From: UnitaryPlanSubmissionForm@donotreply.aucklandcouncil.govt.nz
To: [Unitary Plan](#)
Subject: Unitary Plan Publicly Notified Submission - Plan Change 94 - Dennis Katsanos
Date: Sunday, 28 January 2024 10:30:18 pm

Plan change number: Plan Change 94
 Plan change name: PC 94 (Private): Wairaka Precinct

Submission by The Tree Council on Plan Change 94 Te Auaunga Precinct

Submission to Auckland Council: Proposed Plan Change 94 – Wairaka/Te Auaunga Precinct, private plan change by the Ministry of HUD

Cl23 E(F) 1 response is incorrect

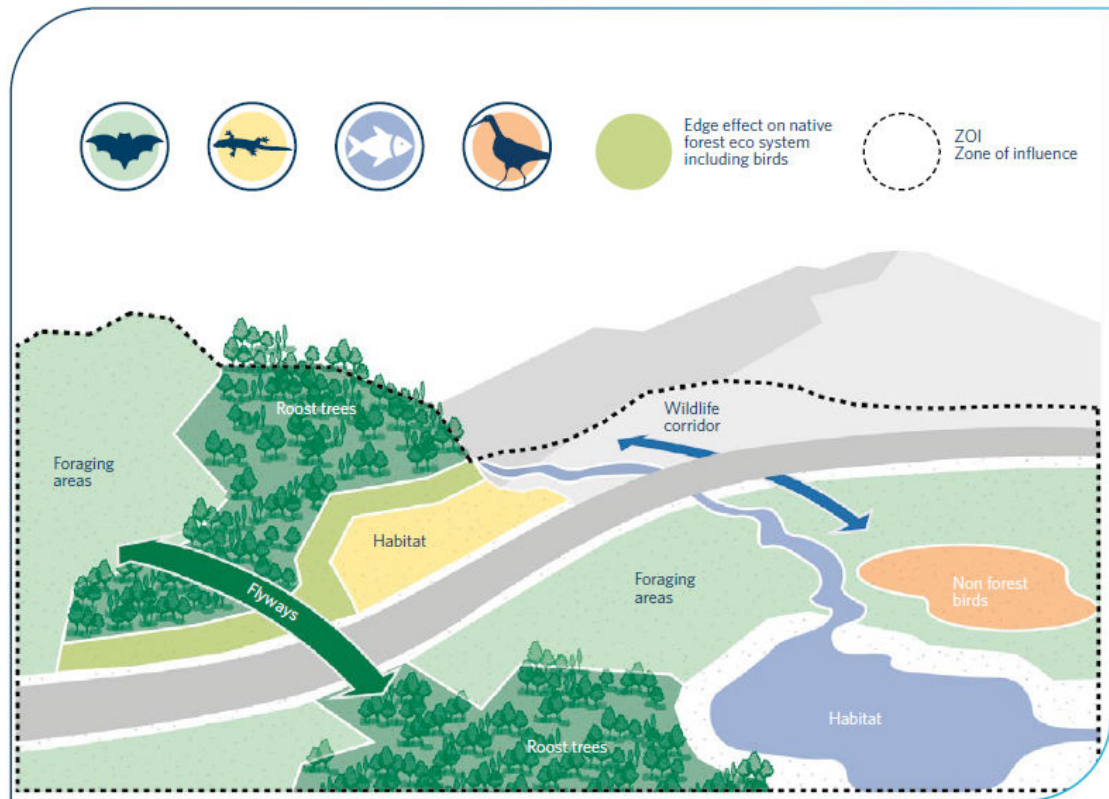
14.15 The use and activities that occur within the precinct are physically separated from the marine environment by Great North Road and the motorway interchange. The potential impact is primarily through water quality issues as the Te Auanga Precinct is within the Oakley Creek catchment.

14.16 The statement is incorrect. The Great North RD interchange is not a separation in ecological terms (ref to the simple NZTA leaflet in LV AEE considerations). The native planting surrounding the Great North Rd interchange is a coastal forest that connects marine and riparian ecosystems and are a mitigation measure of *SH20 Waterview connection*. It was considered highly effective mitigation in terms of plant associations, bird habitat, ecosystem connection among others.

14.17 Amenity value was provided through the shared path. The physical connection of parks and reserves was a mitigation measure of *SH20 Waterview connection*.

Map 1: Zoning

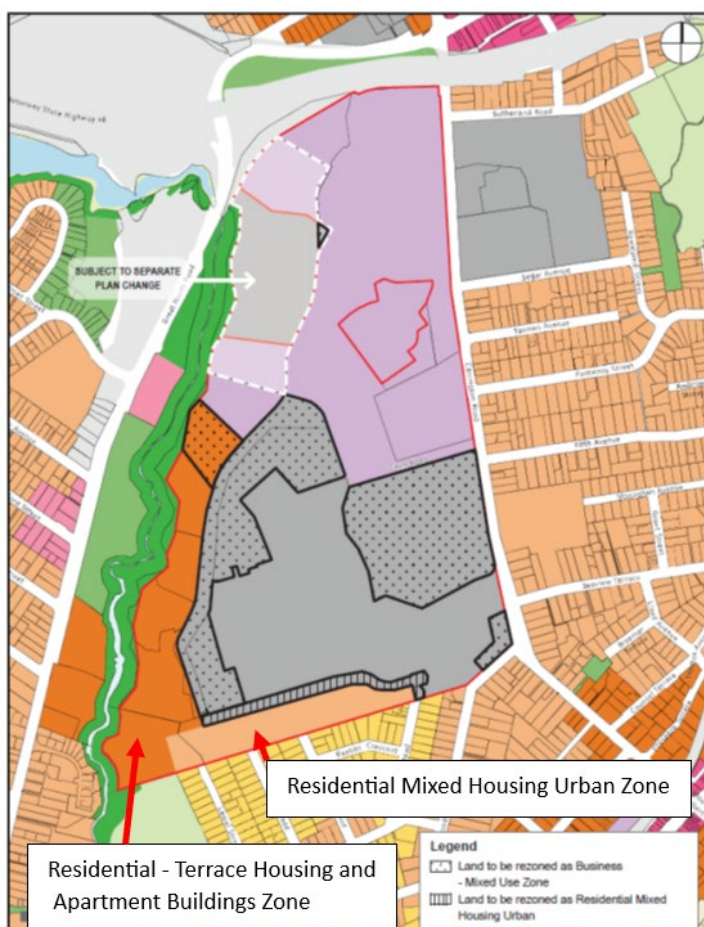
- The proposed precinct provisions relating to the Residential - Terrace Housing and Apartment Buildings and the Residential Mixed Housing Urban Zones, as shown in the Zoning Map 1 below.
